Freshwater Mixed Use Development

50 Lawrence Street
Freshwater, NSW

Development Application
SEPTEMBER 2021

Ground Parking / Retail
SCALE 1:100 @ A3

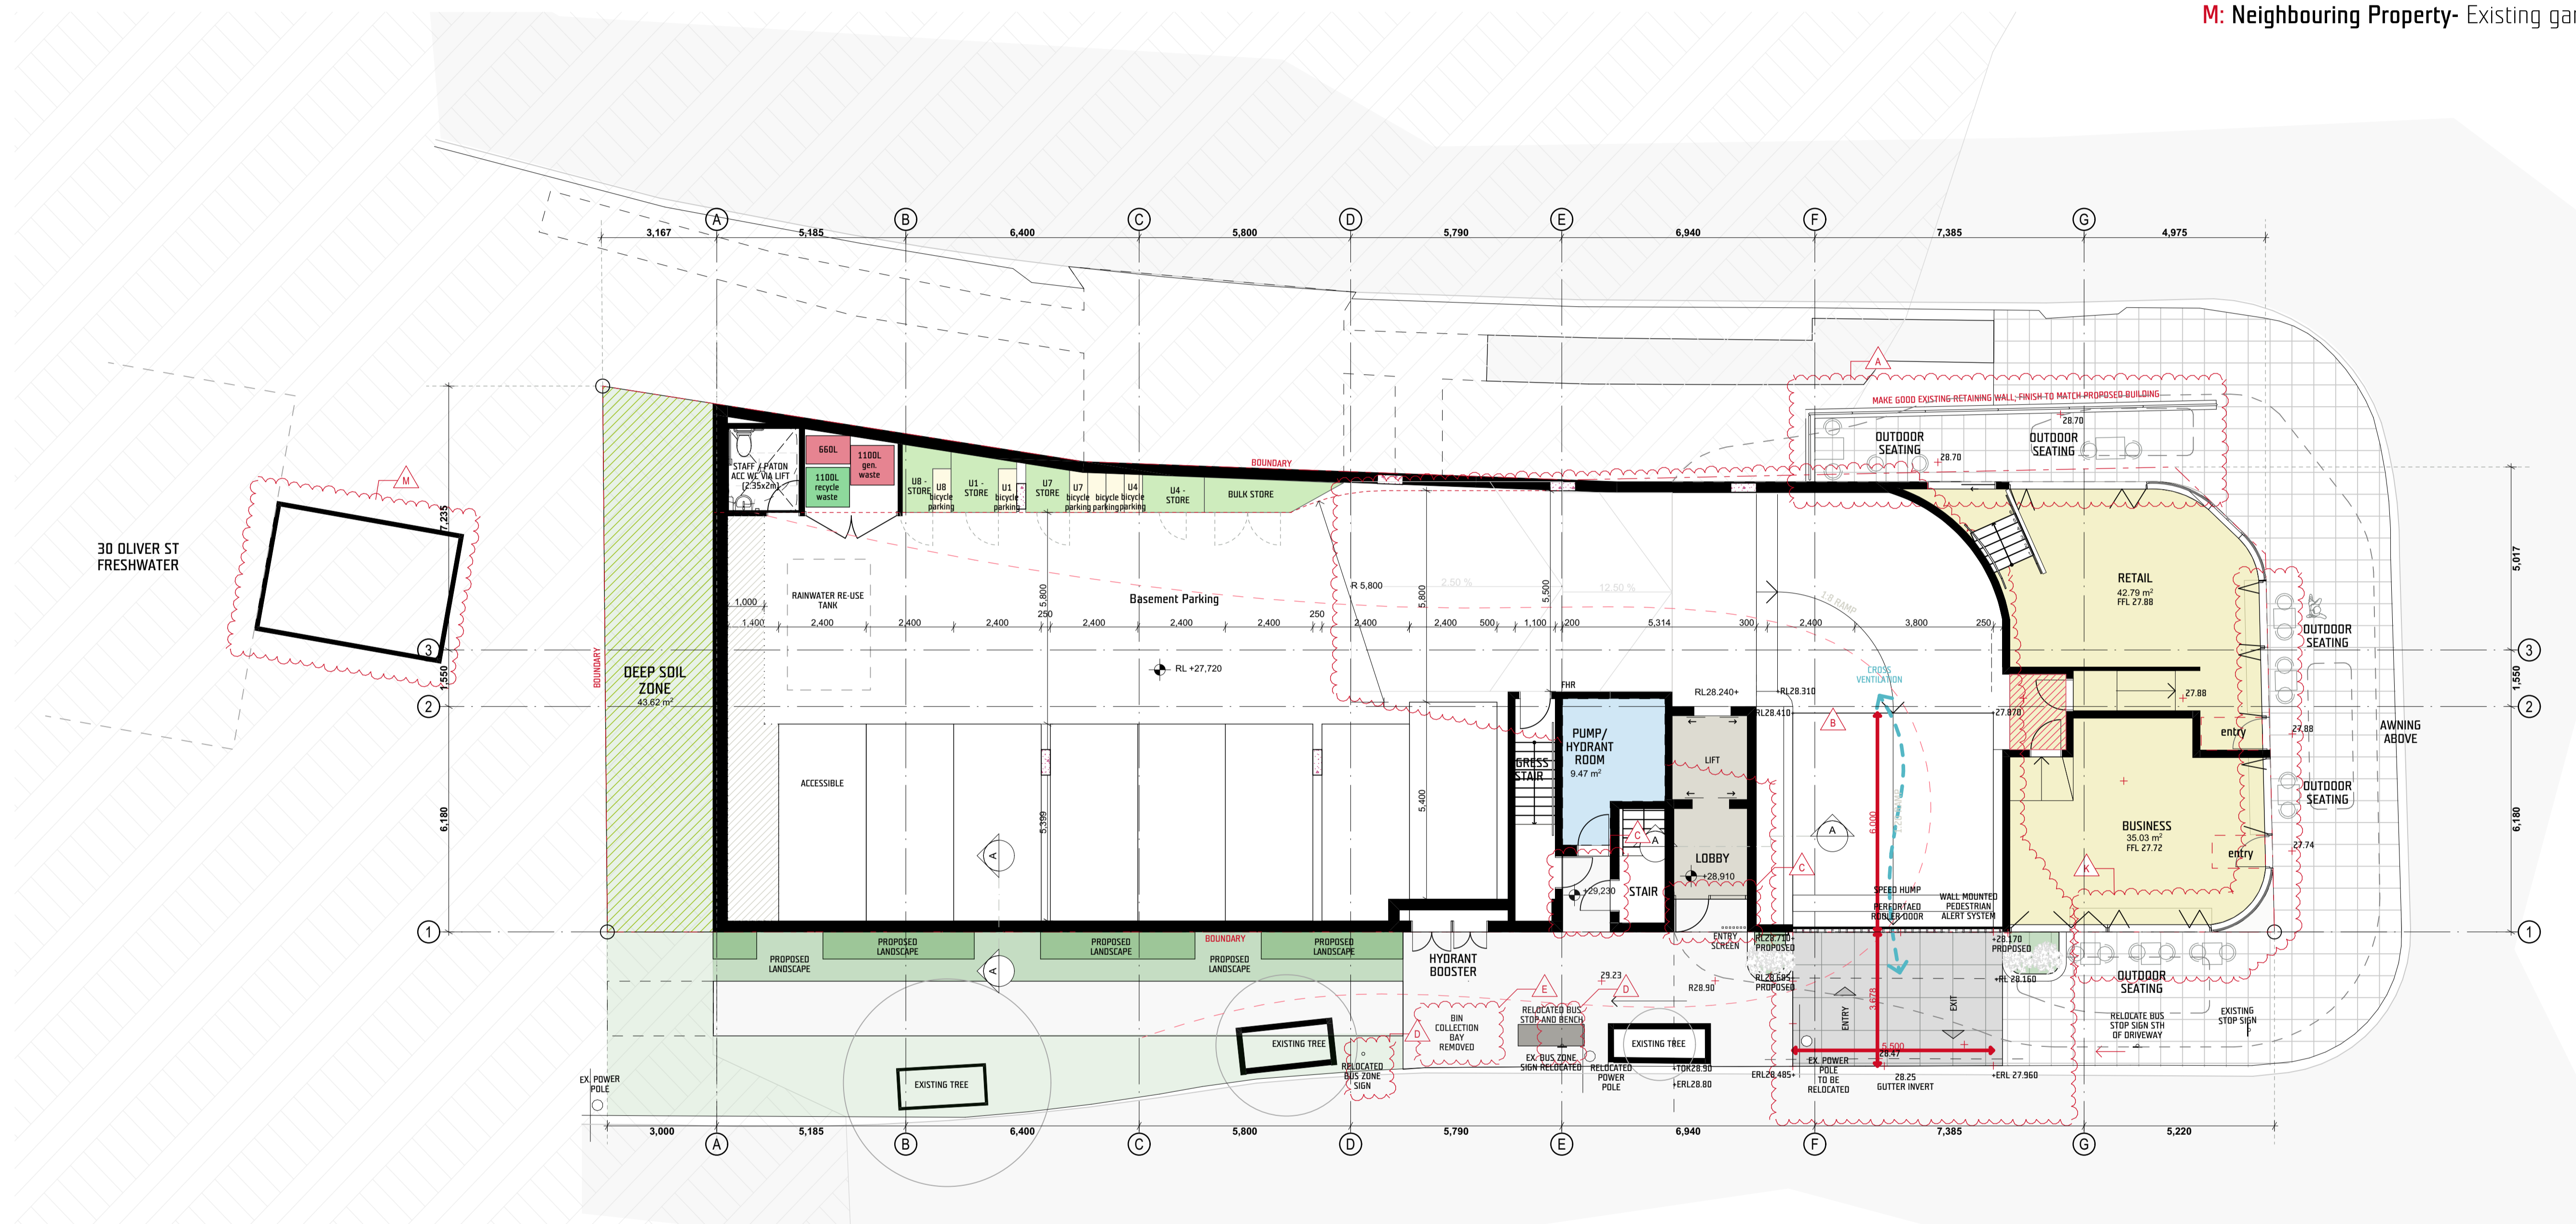
- A: Retaining Wall-** Demolition of southern end/half of the Oliver St retaining wall and removal of associated outdoor seating. Removed past grid F
- B: Vehicular Access-** Driveway amended including width increased to 5.5m, splay added to Dowling Street, and gradients revised.
- C: Egress-** External doors now shows door swinging outwards
- D: Bus stop-** Relocation of bus stop south of Dowling st driveway
- E: Bin Collection Dowling St-** Removed
- K: Retail Glazing-** Windows revised to fold inwards, and shelf removed externally.
- M: Neighbouring Property-** Existing garage added to plans for clarity.

L1 Parking / Units
SCALE 1:100 @ X3

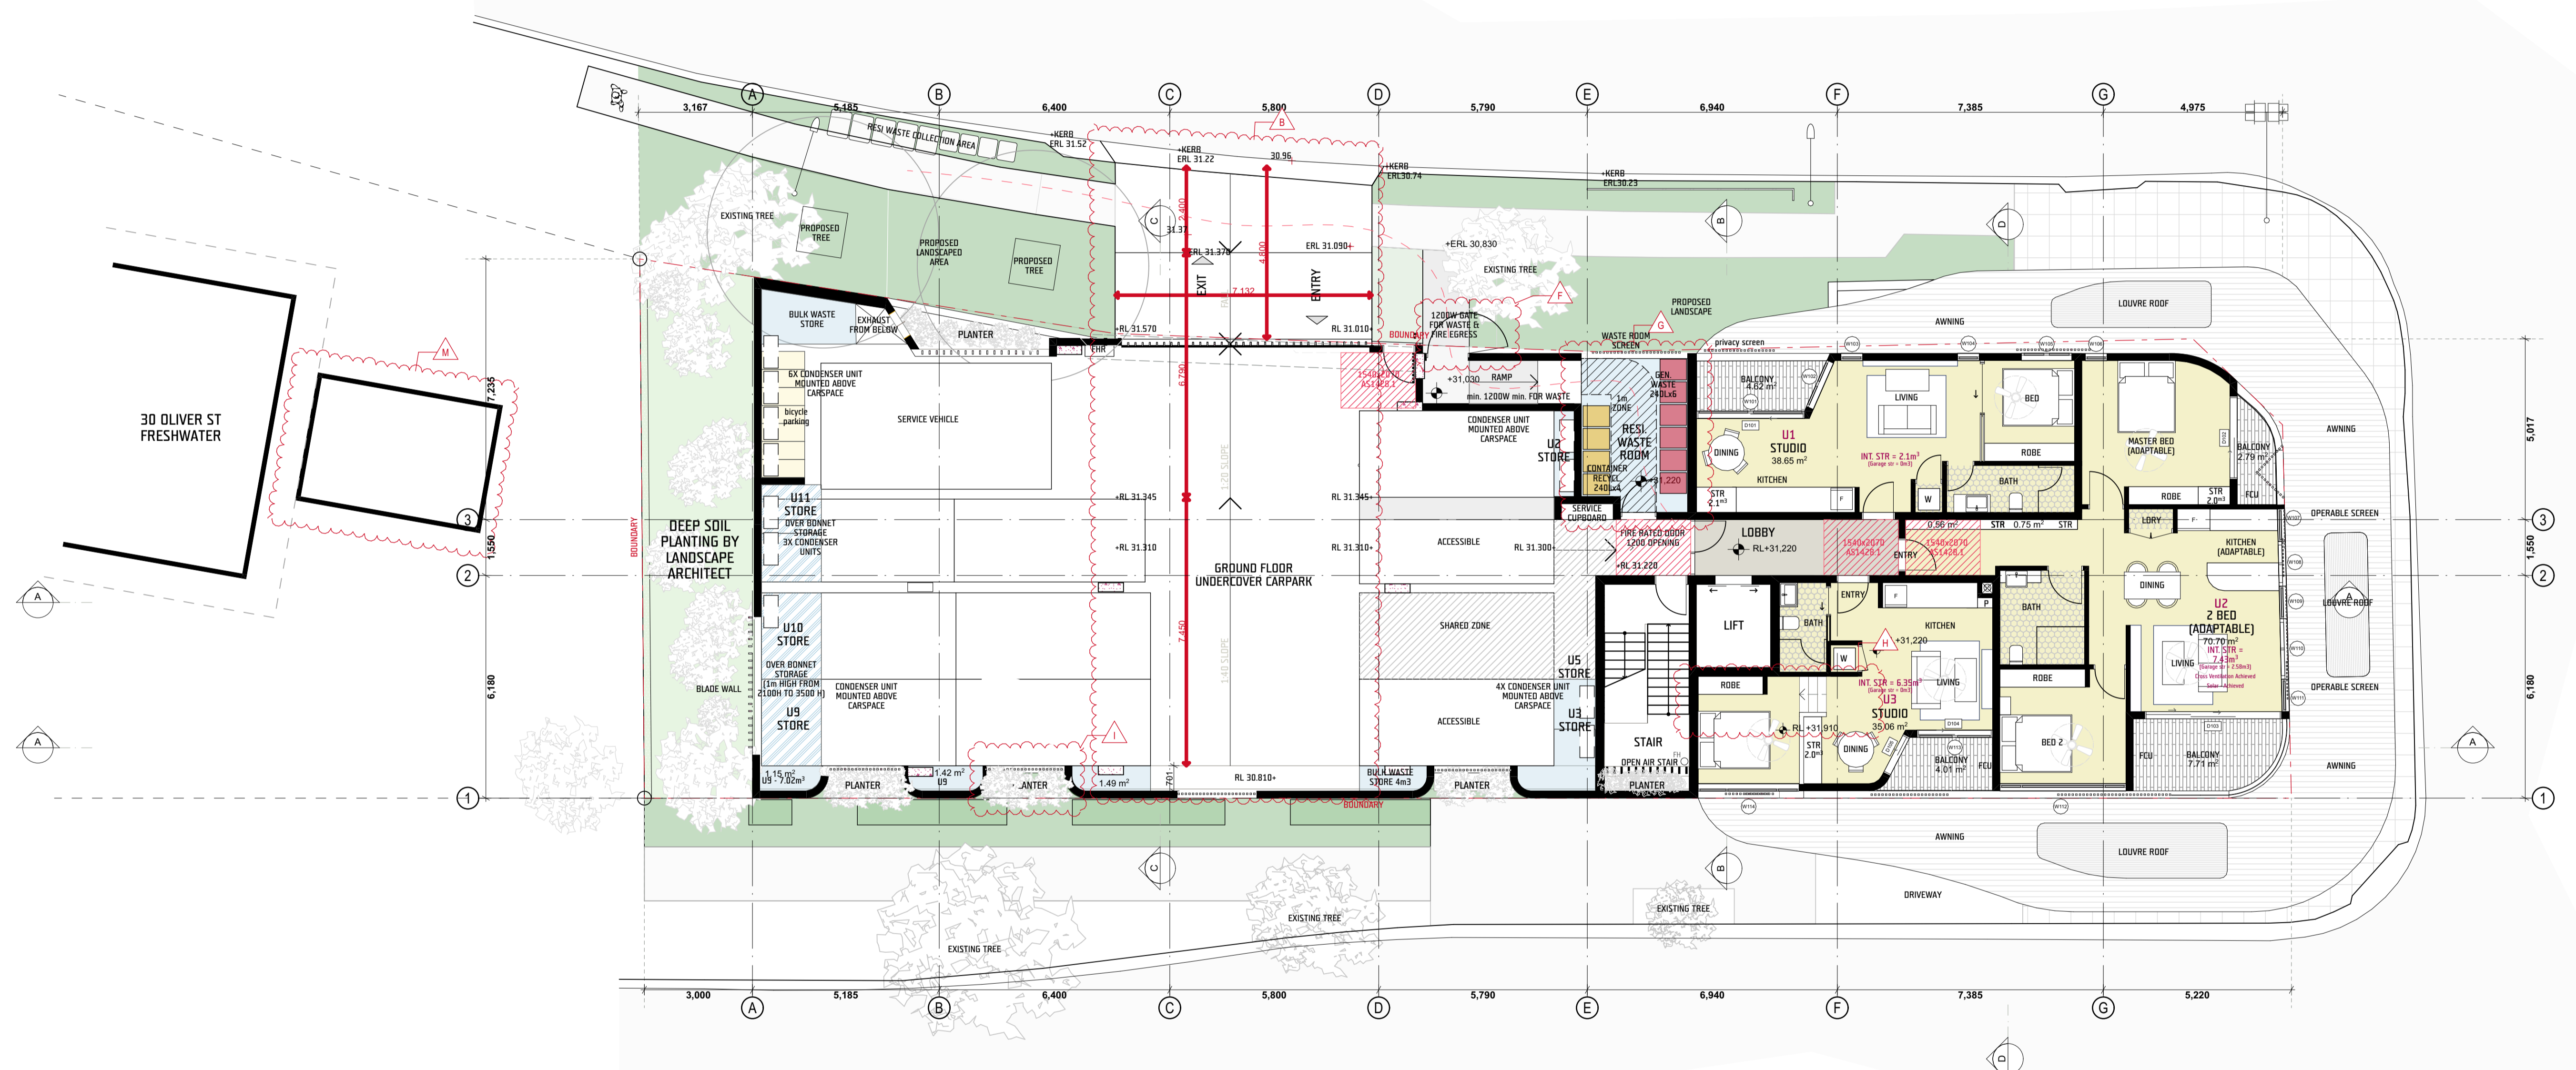
- B: Vehicular Access-** Driveway amended including width increased to 5.5m, splay added to Dowling Street, and gradients revised.
- F: Waste Management-** External Door to bin room now opens outwards with latch. Footpath extension to meet driveway also shown.
- G: Waste Management-** Internal Door to bin room now removed. Bin room accommodates 6 red and 4 yellow 240L bins. Total 10
- H: UNIT 3 Section-** Please refer to page DA 3003 for bedroom ceiling height.
- I: Planter/Slab Edge-** Please refer to page DA 3003 for section
- M: Neighbouring Property-** Existing garage added to plans for clarity.
